CITY OF ALBUQUERQUE

**RE: Lot 16 Block 2 Unser Cliffs SAD 227
6916 Rim Rock NW
Grading and Drainage Plan
Engineers Stamp Date 6/20/18 (D10D013)
Pad Certification Date 7/9/18**

DRAINAGE AND TRANSPORTATION INFORMATION SHEET (REV 6/2018)

ENGINEER'S SEAL 6/20/18 DAVID SOULE P.E. #14522	LOT 16, BLOCK 2 UNSER CLIFFS SUBDIVISION GRADING AND DRAINAGE PLAN 1608 CENTRAL AVENUE SE SUITE 201 ALBUQUERQUE, NM 87106 (505) 972-0899	DRAWN BY DEM DATE JUNE 2018 LOT 16 BL 2 UNSER CLIFFS GAO
		SHEET # C1 JOB #

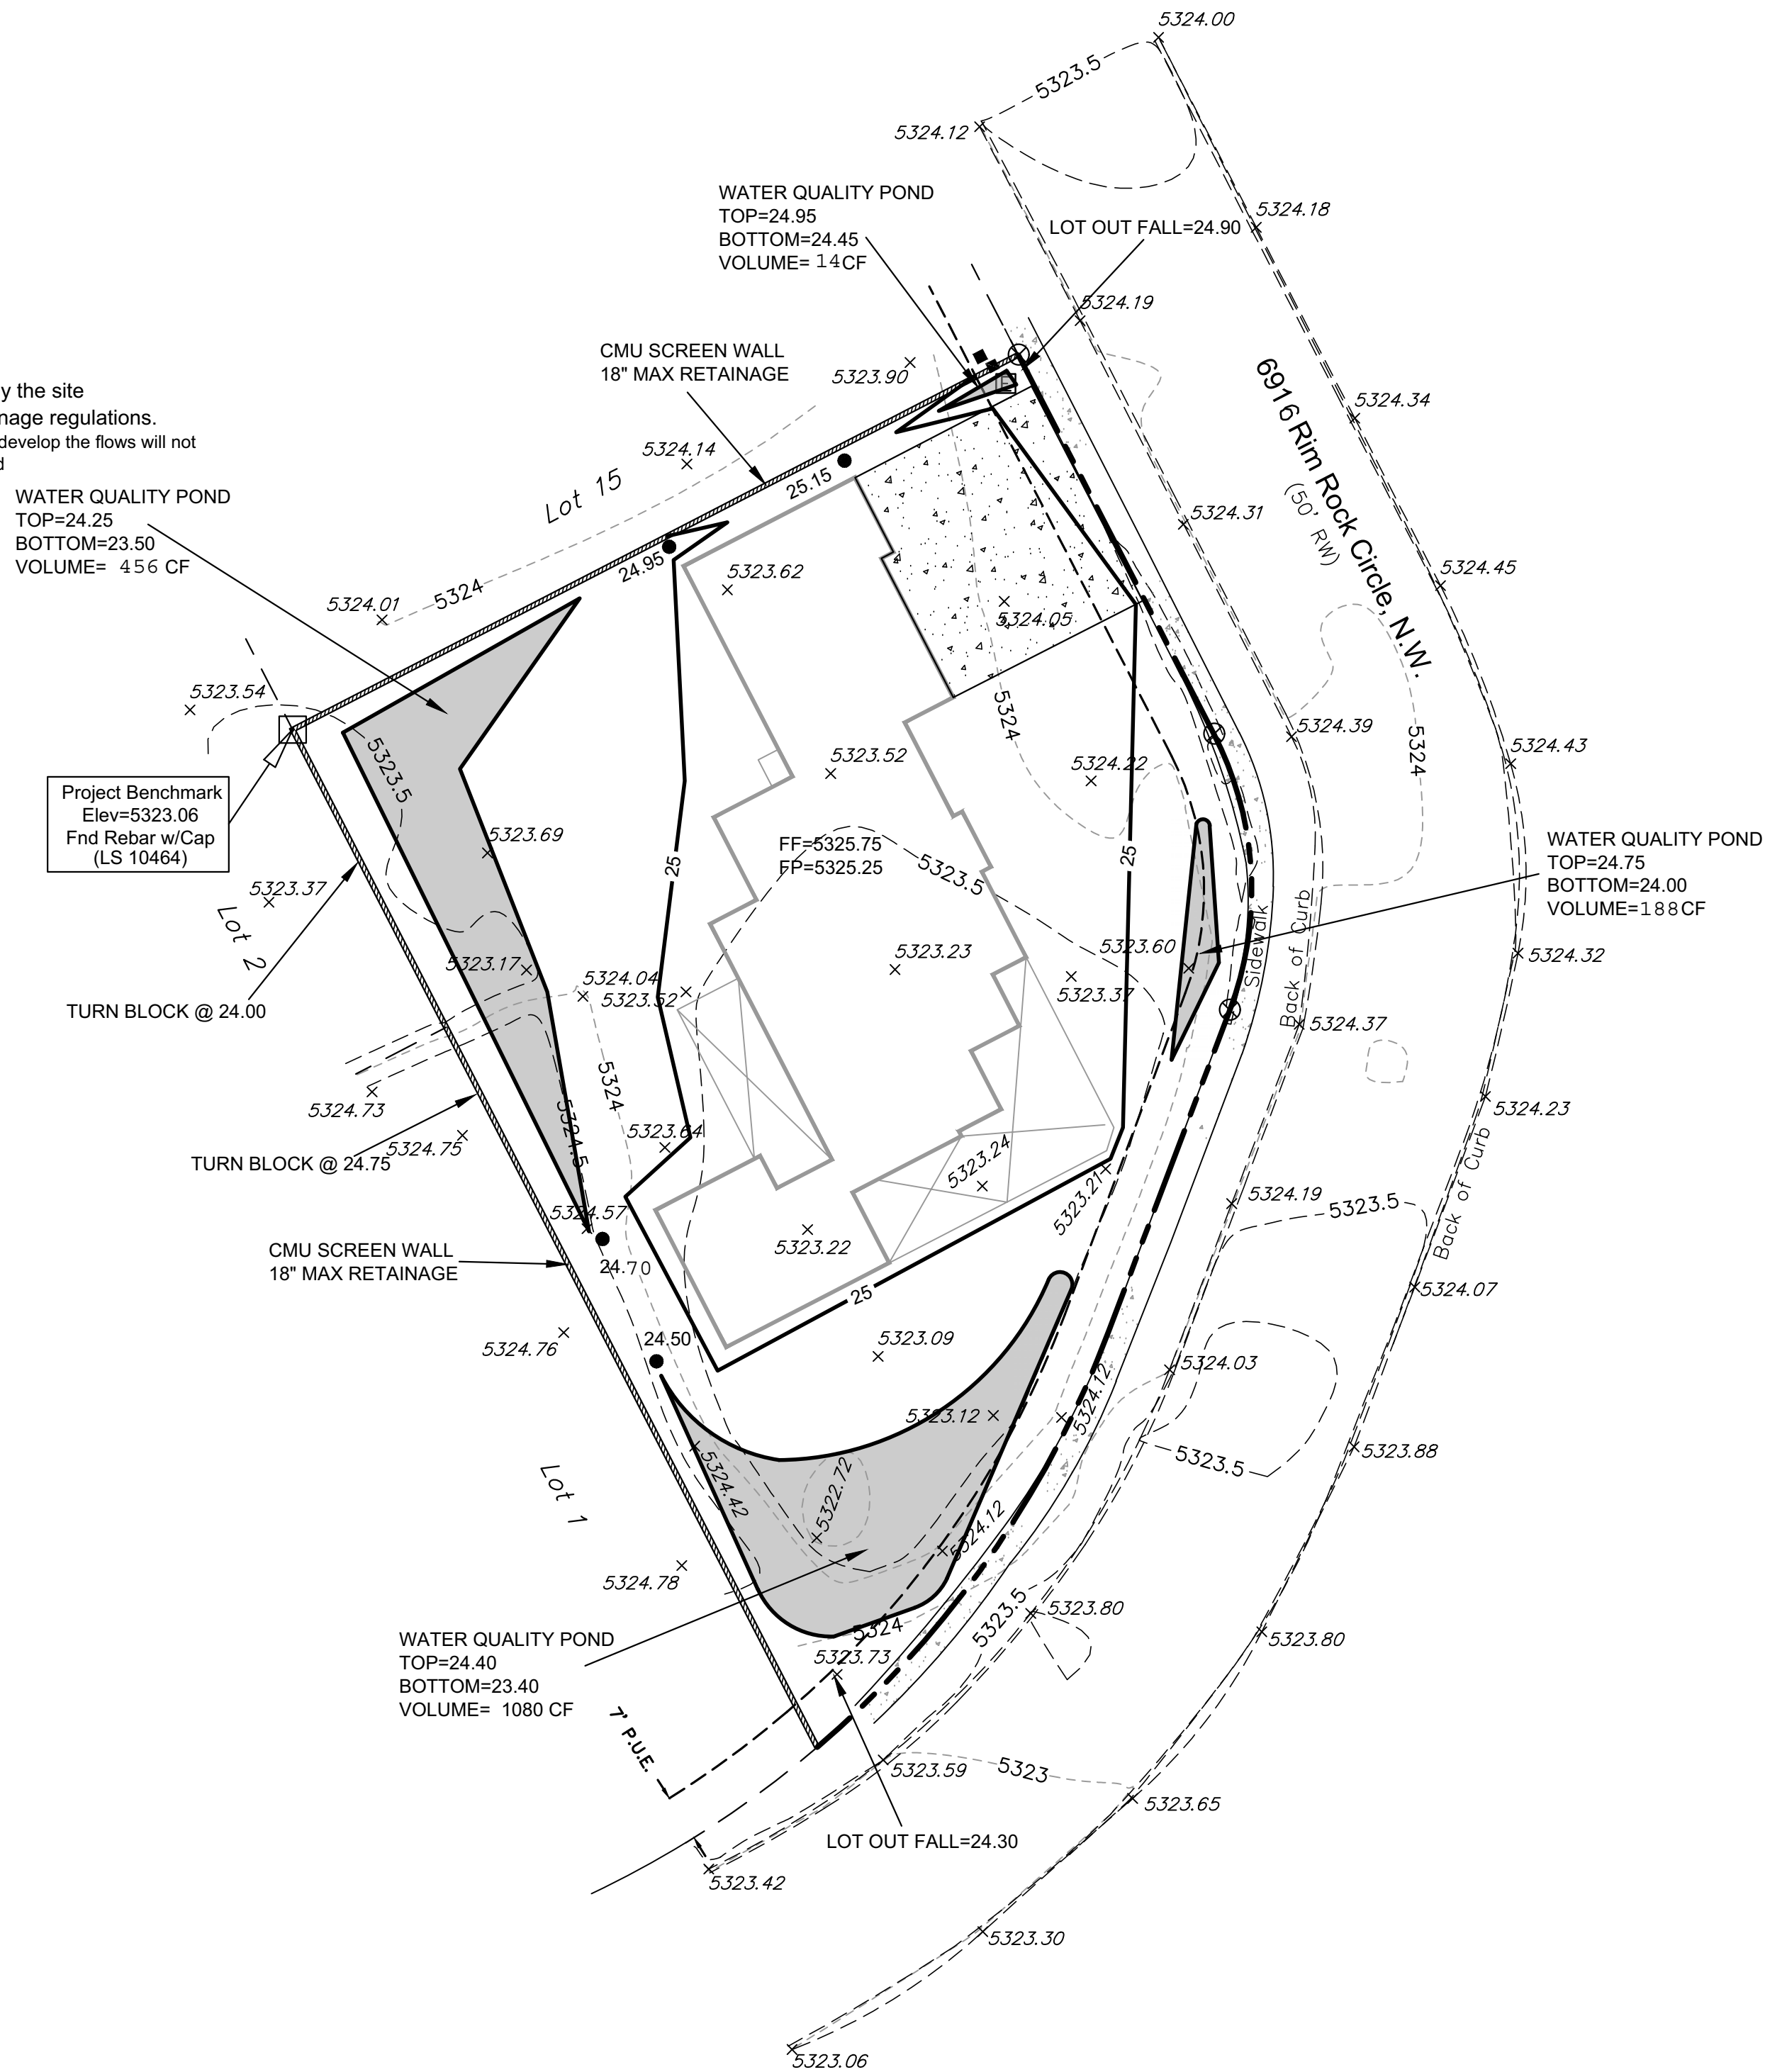
Based upon the information provided in your submittal received 7/9/18, this plan is approved for Building Permit.

Reiterate to the Owner/Contractor that a separate permit for a garden/retaining wall must be obtained, with the approved G&D plan dated 6/20/18.

Prior to Certificate of Occupancy release, Engineer Certification per the DPM checklist of this plan will be required.
